Well Name: EAGLE 34 L FEDERAL	Well Location: T17S / R27E / SEC 34 / NWSW /	County or Parish/State: EDDY / NM
Well Number: 58	Type of Well: OIL WELL	Allottee or Tribe Name:
Lease Number: NMLC067849	Unit or CA Name:	Unit or CA Number:
US Well Number: 300153335300S1	Well Status: Producing Oil Well	Operator: REDWOOD OPERATING LLC

Notice of Intent

Type of Action: Plug and Abandonment

Plug Abandonment NOI Proposed

Redwood Operating, LLC		PROPOSED	
Author:	Abby @ BCM	Well No.	#58
Well Name	Eagle 34 L Federal	API #:	30-015-33353
Field/Pool	Red Lake (Qn-Gb-SA)	Location:	T17S/R27E/ Sec 34
County	Eddy		2310 FSL & 990 FEL
State	New Mexico	GL:	3544
Spud Date	6/6/2004

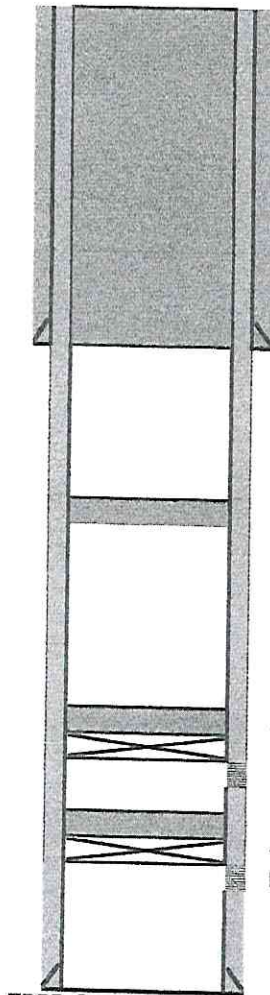
1. Set 5 1/2" CIBP @ 3109'. Spot 25 sx cmt @ 3109-^{2878'}2909'. WOC & Tag.
2. Set 5 1/2" CIBP @ 1804'. Circ hole w/ MLF. Pressure test csg. Spot 40 sx cmt @ 1804-1463'. (San Andres) (1804' to 1447')
3. Spot 25 sx cmt @ 870-670'. (Queen)
4. Spot 55 sx cmt @ 511' to surface. (8 5/8" Shoe & 7 Rivers)
5. Cut off well head, verify cmt @ surface, weld on Dry Hole Marker.

Plug Type	Top	Bottom	Length	Tag	Sacks	Notes
Surface Plug	0.00	511.00	511.00	Tag/Verify		
Fresh Water @ 350	296.50	400.00	103.50	If solid		
Shoe Plug	406.39	511.00	104.61	Tag/Verify	55.00	Spot from 511' to surface. Verify at Surface.
San Andres @ 1513	1447.87	1563.00	115.13	If solid base no need to Tag (CIBP present and/or Mechanic al Integrity Test), If Perf & Sqz then Tag, Leak Test all CIBP if no Open Perforatio		
CIBP Plug	1769.00	1804.00	35.00	If solid base no need to Tag (CIBP present and/or Mechanic al Integrity Test), If Perf & Sqz then Tag, Leak Test all CIBP if no Open Perforatio	40.00	Set CIBP at 1804'. Leak Test CIBP. Spot from 1804' to 1447'.

Perforations Plug (If No CIBP)	1804.00	2494.00	690.00	Tag/Verify		
Glorieta @ 2878	2799.22	2928.00	128.78	If solid base no need to Tag (CIBP present and/or Mechanical Integrity Test), If Perf & Sqz then Tag, Leak Test all CIBP if no Open Perforatio		
CIBP Plug	3074.00	3109.00	35.00	If solid base no need to Tag (CIBP present and/or Mechanical Integrity Test), If Perf & Sqz then Tag, Leak Test all CIBP if no Open Perforatio	25.00	Set CIBP at 3109'. Spot from 3109' to 2878'. WOC and Tag.
Perforations Plug (If No CIBP)	3109.00	3418.00	309.00	Tag/Verify		Not Necessary
Shoe Plug	3438.76	3574.00	135.24	Tag/Verify		Not Necessary

1447'

2878'
